Modecleaner Suspension Design: Steel or Silica Fibres

Responses to questions raised by ribbon/fibre
review committee

16th January 2006
G060013-00-R

Modecleaner Suspension Thermal Noise Estimate (quadratic sum of longitudinal and vertical*)

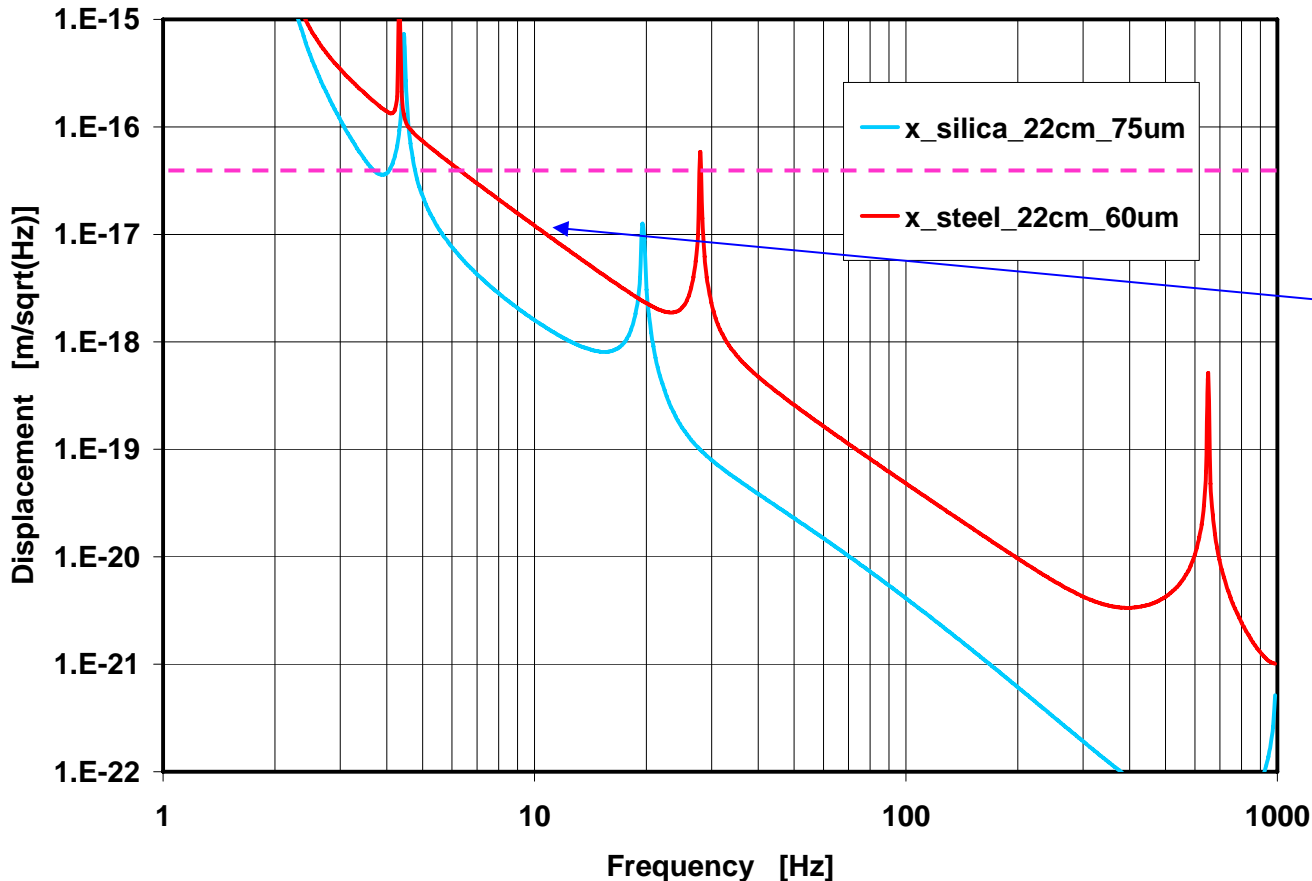
1) How much loss from friction between wire loops and the optic is being assumed for the MC suspension? Where does this come from? How well coupled are these plans and what we are learning from initial LIGO suspensions?

- We have considered both the case where there is no significant loss from friction, using an intrinsic material loss of 2×10^{-4} , and where the loss is assumed to be 10 times larger than this value, based on the findings with Initial LIGO

$1.2 \times 10^{-17} \text{ m}/\sqrt{\text{Hz}}$
@ 10 Hz

If losses are 10 times larger, this value becomes $\sqrt{10}$ larger, still within current noise requirement
